# City of Medford

**Request # 1:** Any email messages and/or attachments sent or received, including CC and BCC emails, that include Lauren DiLorenzo, Director of Community Development for the City of Medford, between January 1, 2019 and present or concern or make mention of any of the following topics:

The Engineering Division received and reviewed a revised plan set (21 sheets) for the Winthrop Estates Definitive Subdivision (the Plan). The revision date is June 24, 2019. The Engineering Division issued a letter dated May 7, 2019 with comments on the original submission. The revised plan appears to address many of these comments; however, some open items remain.

**GT-1**

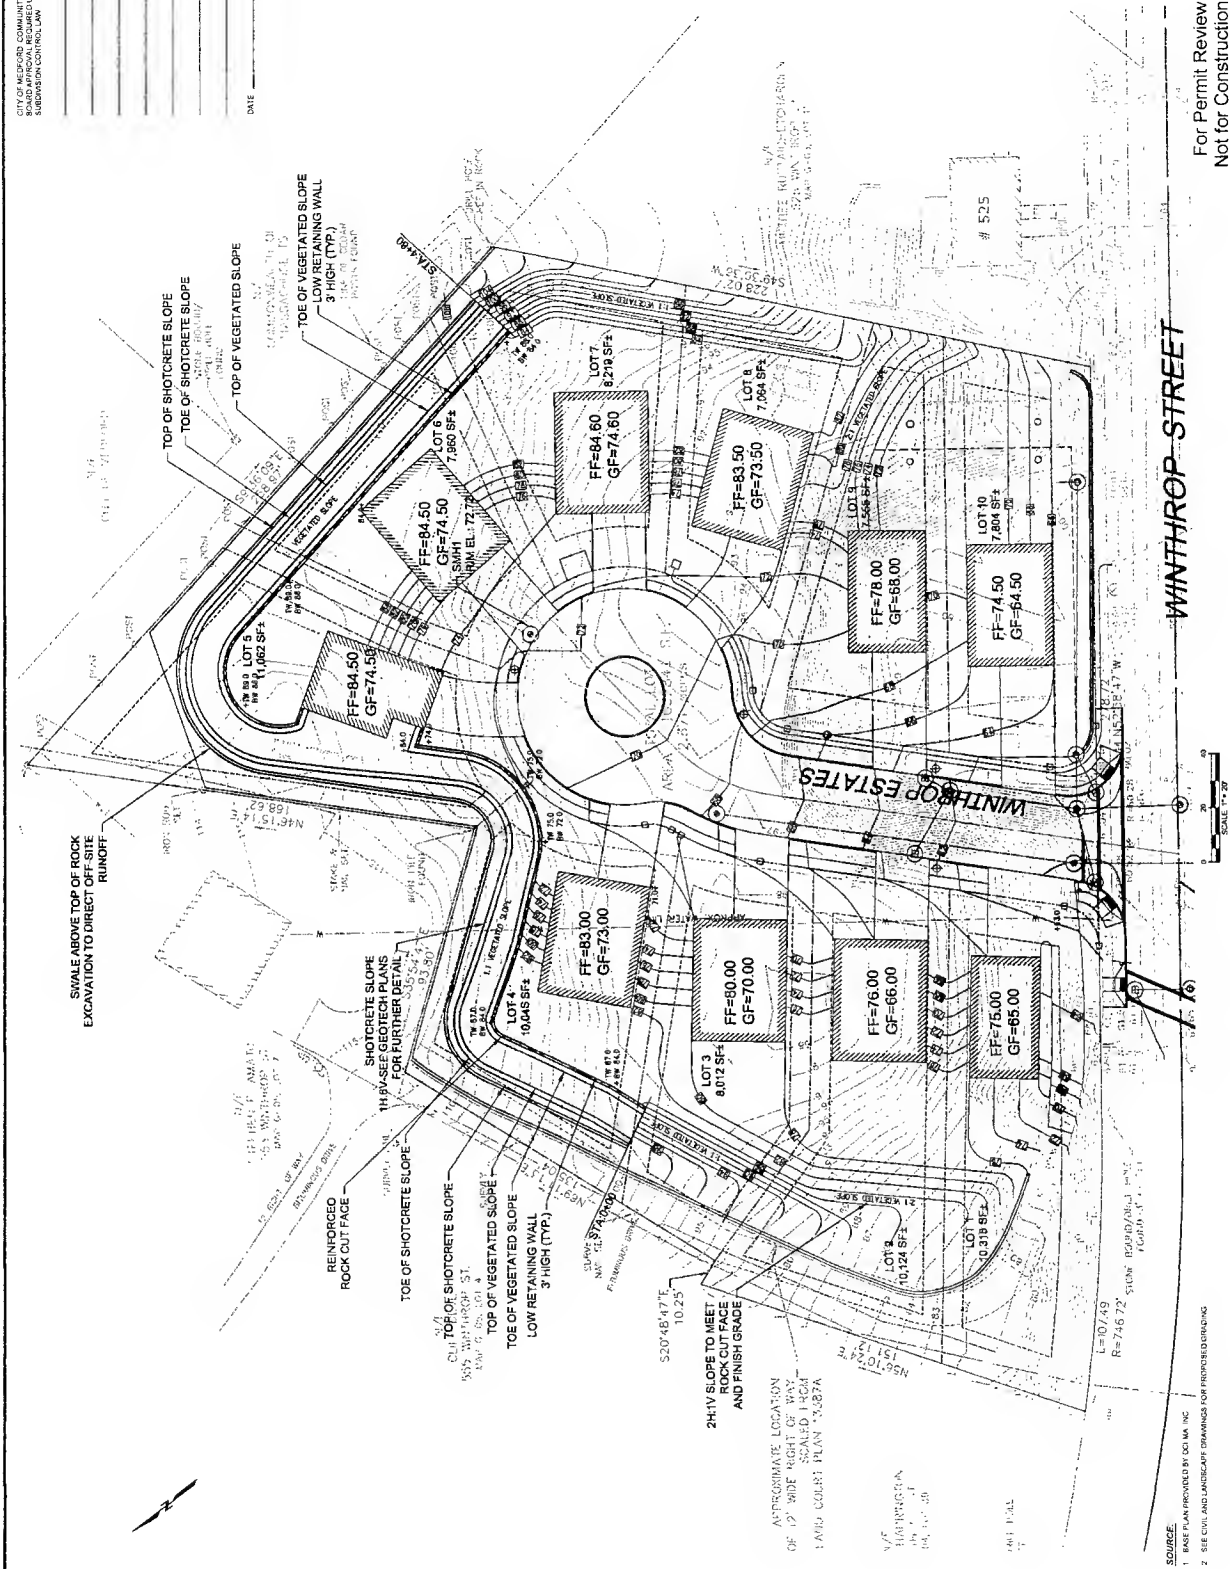
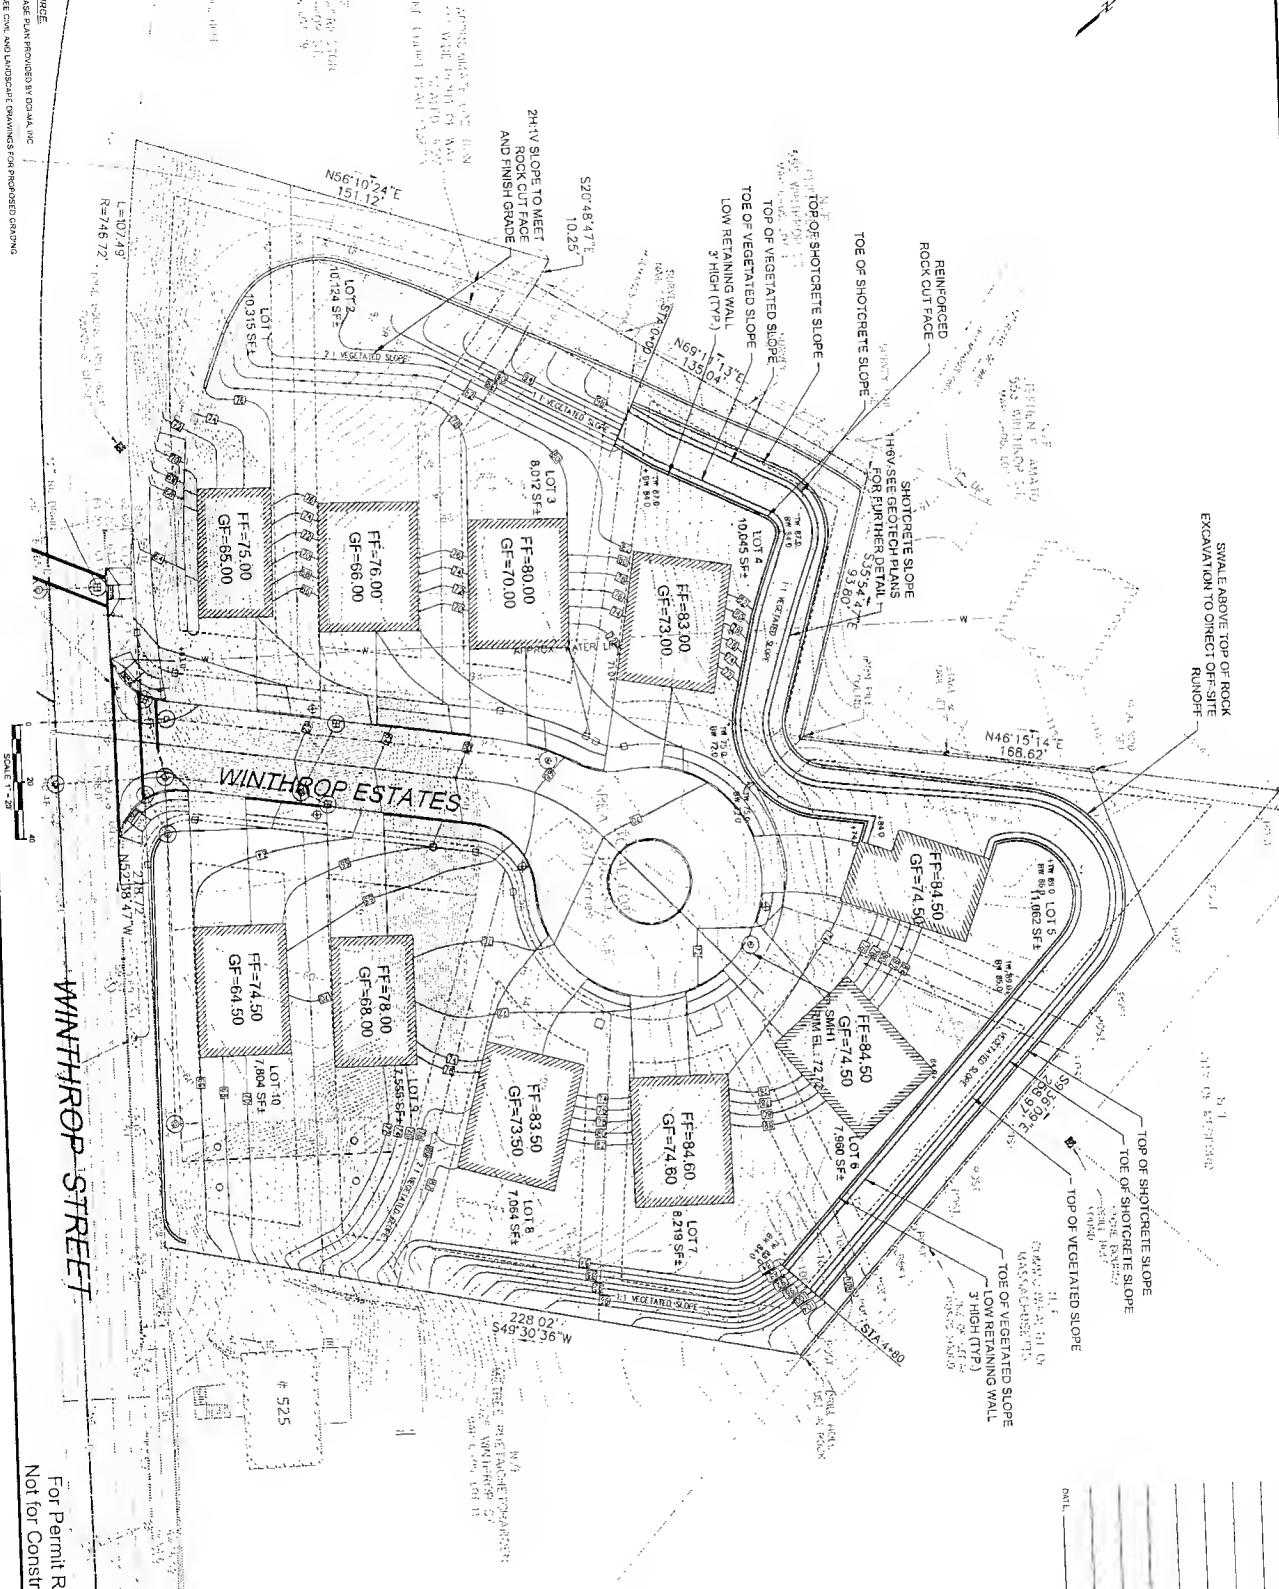
11. *The Plan includes requirements for "Rock Excavation, Rock Face Cleaning & Rock Dowel Installation". Note 2 under these requirements indicates "lifts". The Plan should be revised to include heights of the lifts required in each step of the construction process. This should include, but is not limited to, the maximum height of rock face prior to stabilization, and the height of vegetated slopes prior to stabilization.*

**The comment is not fully addressed. Please revise the Plan to include the height of vegetated slopes prior to stabilization.**

DCI Response: “(per Frank Leathers, GEI): Drawing GT-5, Section titled “Rock Excavation, Rock Face Cleaning and Rock Dowel Installation”, Note 2 – sentence has been added “Maximum excavation lift height shall be 9 feet below top of rock or lowest previously installed row of dowels.””

1 CATCH BASIN (CB)  
NOT TO SCALE

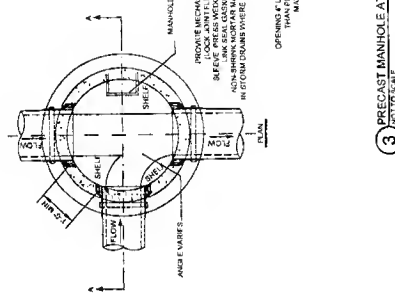
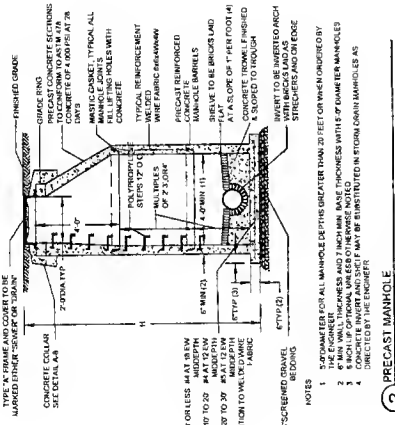
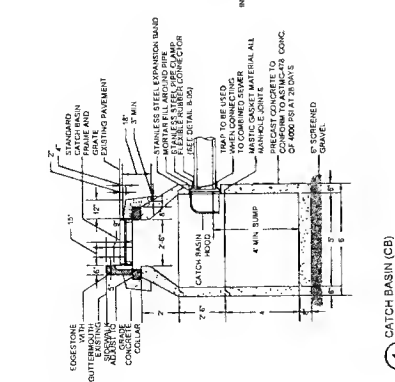
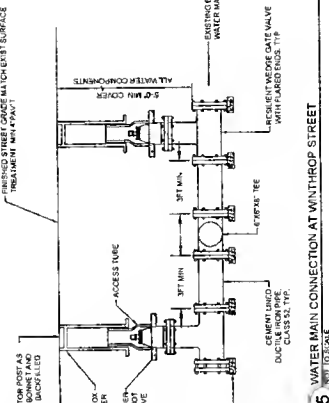
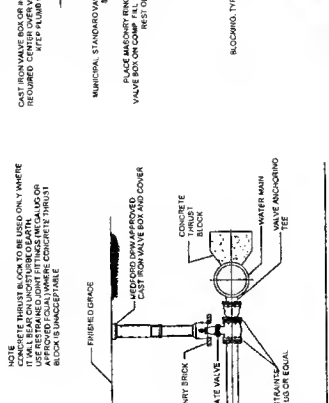
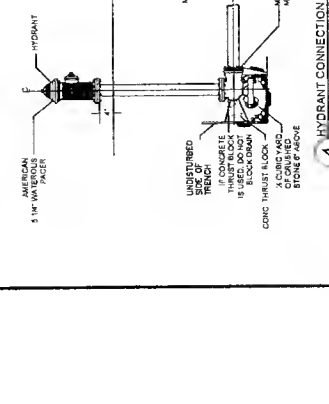
- 19c. Detail 7 on Sheet C6.0 includes a reference to existing water service couplings and does not include a buried water box at the corporation stop. The Plan should be revised to remove incorrect references and to include a water gate box over the corporation stops buried to within 18-inches of the roadway surface.

- 19d. Detail 6 on Sheet C6.0 is entitled "Water Service Connection". This appears to be the connection to the Winthrop Street water main. The title should be revised to read "Water Main Connection at Winthrop Street". This detail also indicates a tapping sleeve and valve. Tapping sleeves and valves are no longer allowed in the City of Medford for water main connections. The connection should be revised to include a tee cut into the main.

- 19e. Detail 4 on Sheet C6.0 of a sewer manhole conflicts with other details at the pipe opening. Detail 3 on the sheet appears correct. Please revise accordingly.

*Resolution 2: Detail 4 has been deleted and callouts have been revised accordingly.*

**LIGHTING PLAN**

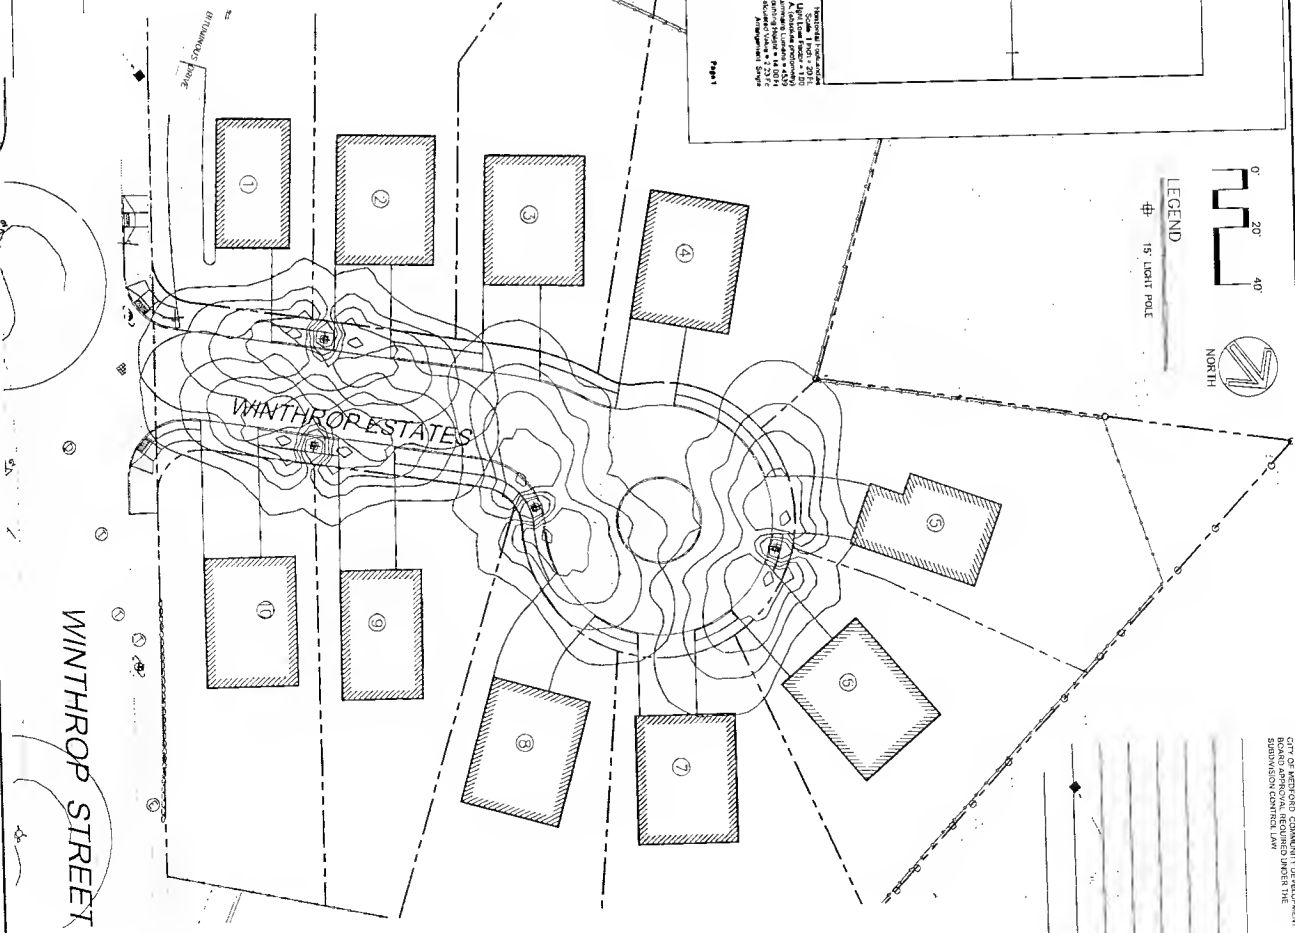
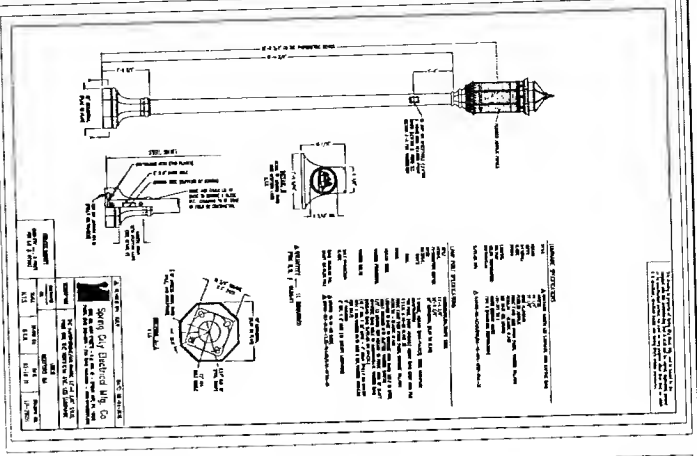
12. *The Plan includes a photometric analysis. This analysis appears to be missing a light near Lot 4. The photometric analysis should be revised to include this missing light, and all other site lights.*

**The Engineering Division recommends that the Proponent obtain and submit a letter to the Board from the Superintendent of Wires approving the Lighting Plan. The Engineering Division also recommends that the Board indicate that the Lighting Plan is subject to approval of the Superintendent of Wires prior to construction.**

DCI Response: The landscape architect has modified the photogrammetric analysis.

10 CATCH BASIN ALONG GUTTER LINE PROFILE  
NOT TO SCALE

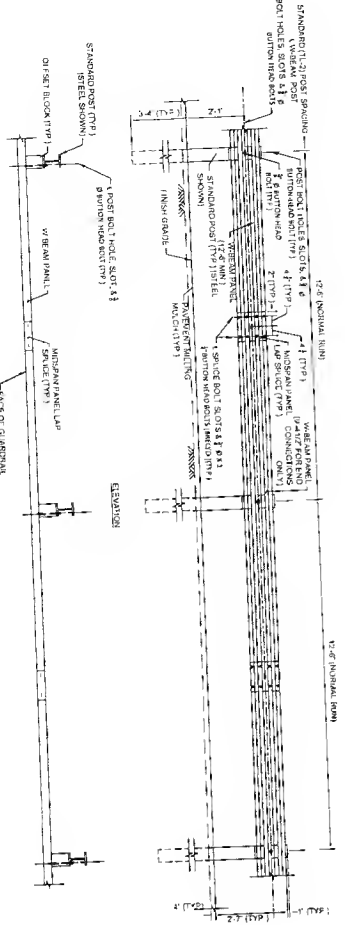
- 19f. Detail 10 on Sheet C6.1 indicates decimal values with no unit. Please revise accordingly.
- 19g. Detail 16 on Sheet C6.1 includes a guard rail. Please confirm that this design meets federal highway guard rail design standards.
